NANNYBO CURVES SUBDIVISION

APPLICATION NUMBER 16 DATE August 2, 2012
APPLICANT Nannybo Curves Subdivision
REQUEST Subdivision

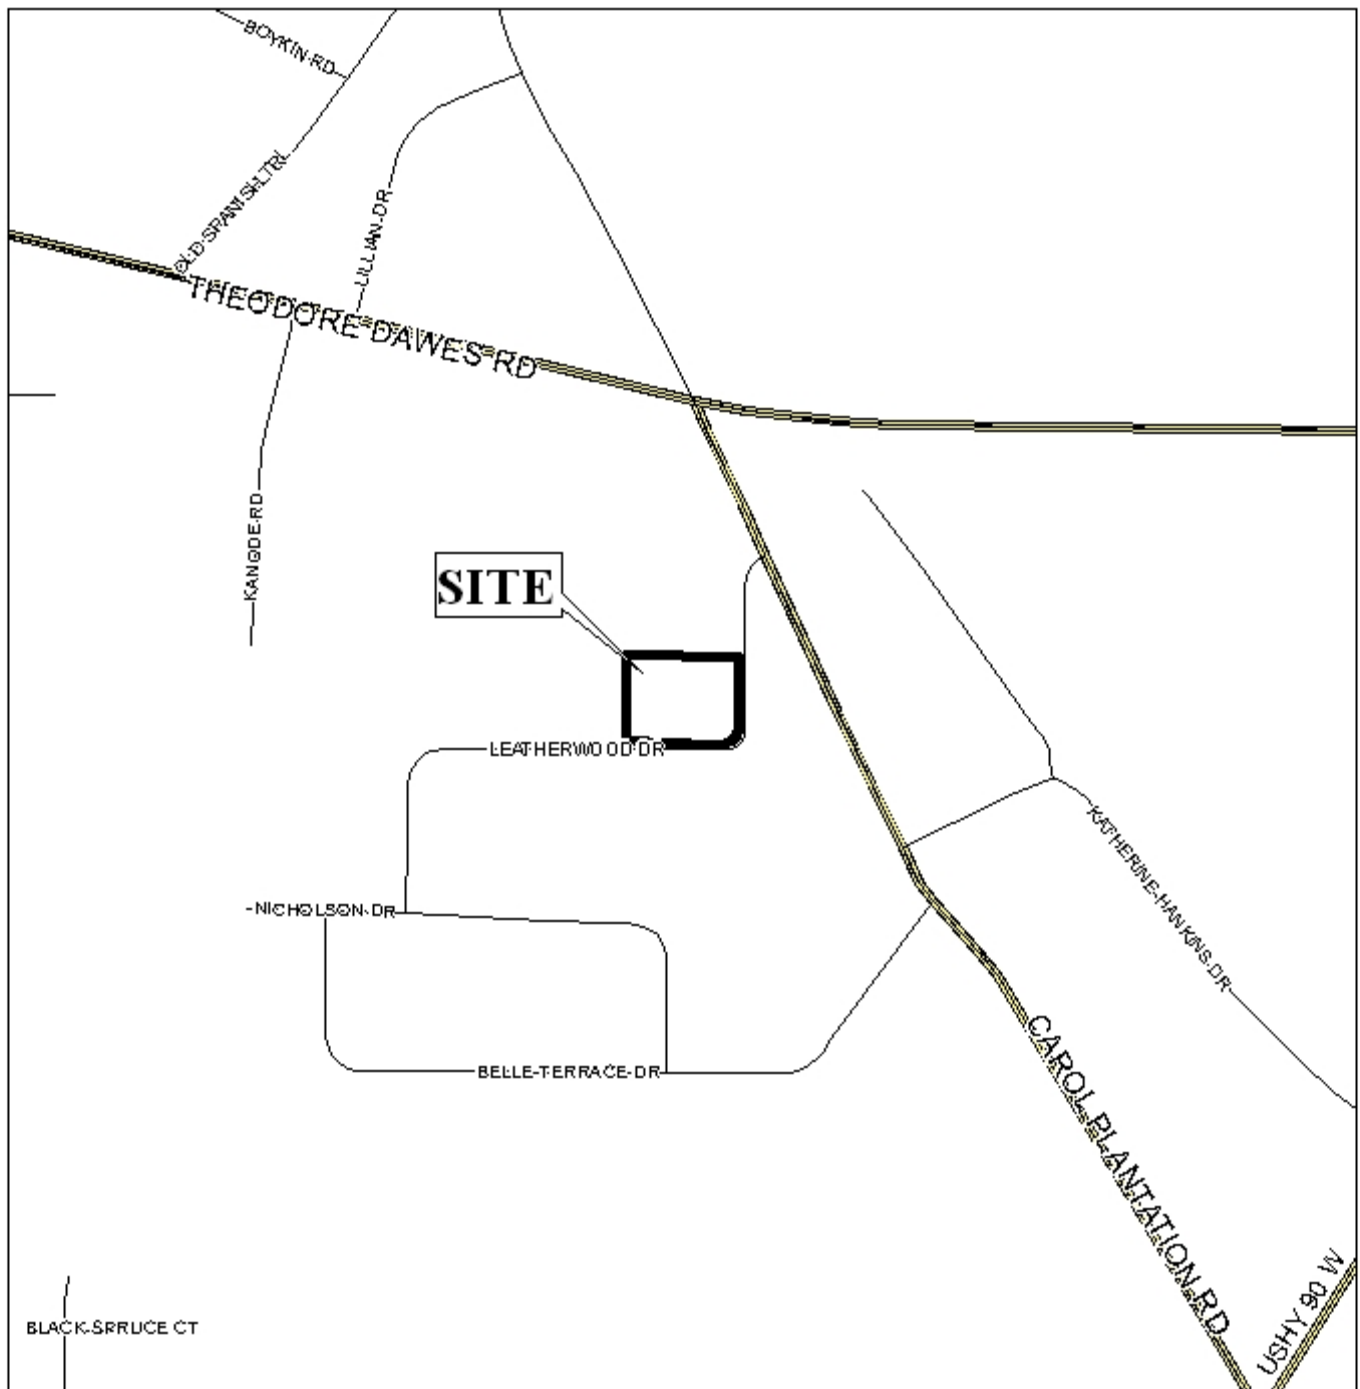
The site fronts onto Leatherwood Drive, an unpaved public street with a 50-foot wide right-of-way according to the preliminary plat. As Leatherwood Drive lacks curb and gutter, Section V.B.14. of the Subdivision Regulations requires that the right-of-way be a minimum of 60-feet in width. Therefore, dedication sufficient to provide 30-feet from centerline should be provided along the entire street frontage of the proposed subdivision. The corner radius depicted on the preliminary plat should be adjusted for dedication, and shown on the final plat, if approved.

The 25-foot minimum setback line is depicted on the preliminary plat, but will need adjustment due to right-of-way dedication.

As the site fronts onto an unpaved street and at a curve, access management is a concern. The existing development on the site has a total of four (4) existing curb-cuts, two for what will become Lot 1 and two for what will become Lot 2. The site should be limited to the existing curb-cuts, with any change in the size, location or design to be approved by Mobile County Engineering, and with changes to conform with AASHTO standards.

The lot size information on the preliminary plat should be retained for the final plat, adjusted for any required right-of-way dedication.

- 1) Dedication of right-of-way along Leatherwood Drive sufficient to provide 30-feet from centerline, with corner radius dedication;
- 2) Revision of the 25-foot minimum building setback line to reflect dedication;

- 3) Revision of the lot sizes to reflect dedication;
- 4) Placement of a note on the final plat stating that each lot is limited to the two existing curb-cuts per lot, with any changes to the size, design or location to be approved by Mobile County Engineering and to comply with AASHTO standards;
